No.	DATE	CHANGED	BY	APPROVED	DATE
4	6-29-59	BEAM LOCATION, SIZE & SUPPORT	R.P.M.		6-29-59

DRAWN BY R.P. MORSE	DATE 3-18-59	M.P.C. BLDG. 12-30 PAINT SHOP
CHECKED A.T.D.	5-11-59	
CHECKED L.M.K.	5-11-59	
CHECKED L.E.H.	6-29-59	BOEING AIRPLANE CO.
APPROVED	5-11-59	SEATTLE 24, WASH.
APPROVED

SCALE AS NOTED
ISSUE DATE OF PRINT
ISSUE NUMBER
JOB NUM ISS 578856
WORK ORDER NUMBER
DRAWING NUMBER 112-030-1004-A1

I BEAM ANCHOR DETAIL 3" = 1'-0"
CANCELLED BY CHANGE 4

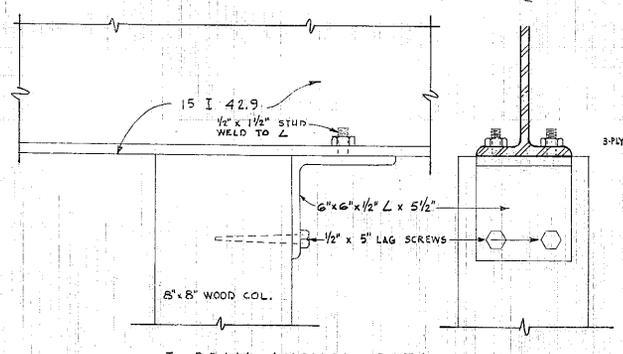
NOTES RELATIVE TO CHANGE 4
1. USE (2) 10" I 25.4 IN LIEU OF (1) 15 I 42.9
2. 3"x3"x3/8" L BRACKET SUPPORT FOR BEAMS. USE 6' LENGTH AT SOUTH END OF BEAMS. 1/4"x4" LAG SCREWS INTO EA. STUD
3. USE EXIST. MANUFACTURED BRACKETS AT N. END OF BEAMS (4) 1/2"x6" LAG SCREWS INTO EA. COL.
4. USE (2) 1/2" BOLTS BEAM TO L BRACKET
5. USE (2) 1/4" LAG SCREWS INTO BEAM AT MF'D. BRACKET.
